CASE COMMENT REPORT

CASE NO. UDP-RS24002

CASE:	UDP-RS24002
MEETING DATE:	February 27, 2024
REQUEST:	Site Plan Level II Review: Sign Request for Three (3) Roof Signs in the Regional Activity Center
APPLICANT:	PAWACQCO Holdings 5, LLC.
AGENT:	Courtney Crush, Crush Law, P.A.
PROJECT NAME:	Park Plaza Signage
PROPERTY ADDRESS:	600 SE 2nd Court
ZONING DISTRICT:	Regional Activity Center - East Mixed-Use District (RAC-EMU)
LAND USE:	Downtown Regional Activity Center
COMMISSION DISTRICT:	4 - Warren Sturman
NEIGHBORHOOD ASSOCIATION:	Beverly Heights Association
CASE PLANNER:	Tyler Laforme

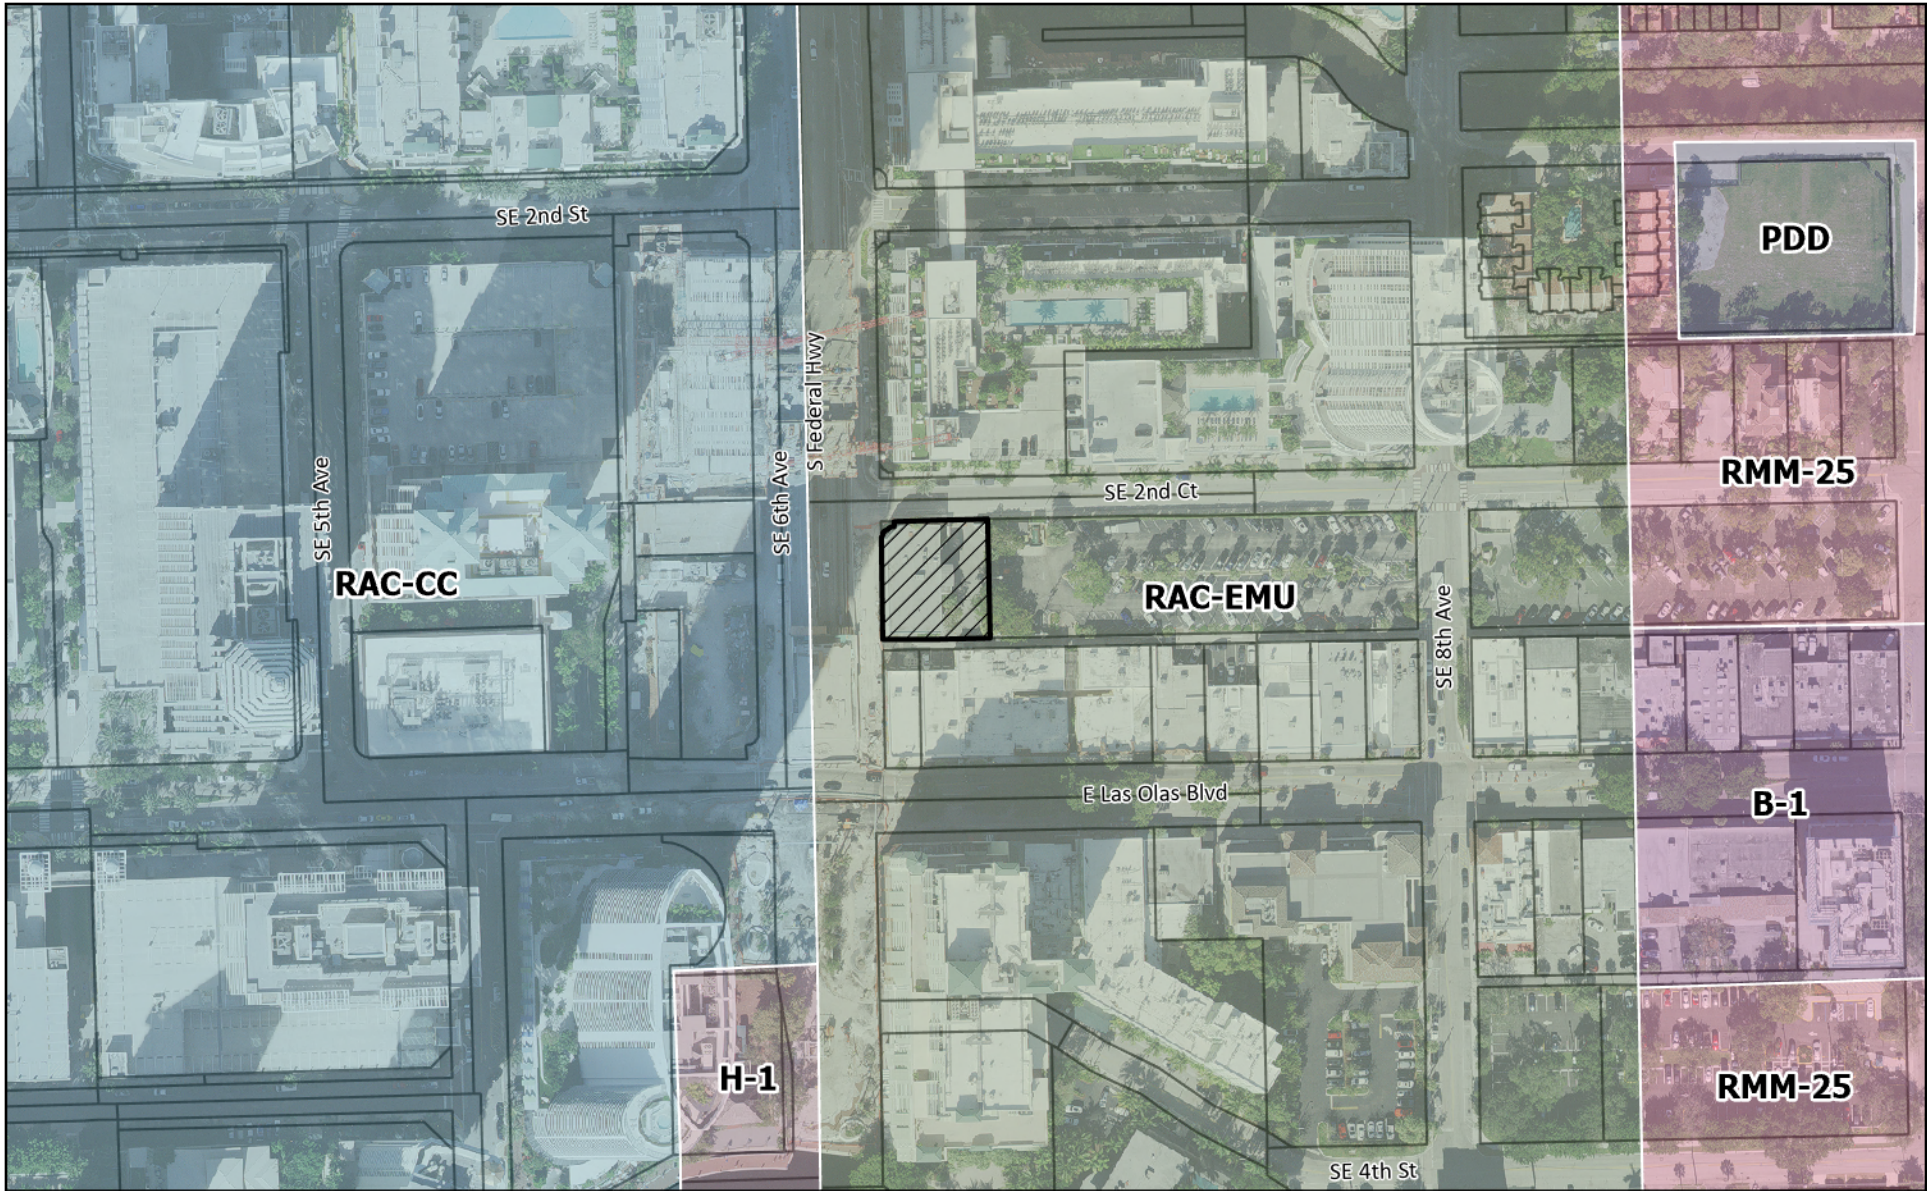
5. Applicant's narrative is incorrect on number of trafficways the property fronts which impacts the applicant's request in regards to quantity. In addition, the justification for above canopy signage is not sufficient unless the applicant can demonstrate through graphic illustrations on sight views as stated in the narrative. Update accordingly.

6. Provide the floor plans for the tenants that indicate the location of tenant entrances.
7. Proposed supportive mounting raceways should not be exposed. Revise to address this matter with another supportive technique.

8. At this time, staff cannot recommend the signs project higher than the parapet wall. Adjust location of Signs 2 and 3.
9. Provide the following changes to signage:

- a. Provide the dimensions of the depth of the signage on the cross sections for all signs.
 - b. For the "Howl at the Moon" signage (S2 and S4), clarify if the wolf icon is pushed through the entire signage.

- c. Provide additional details in the lettering sections, specifically regarding the material of the lettering.
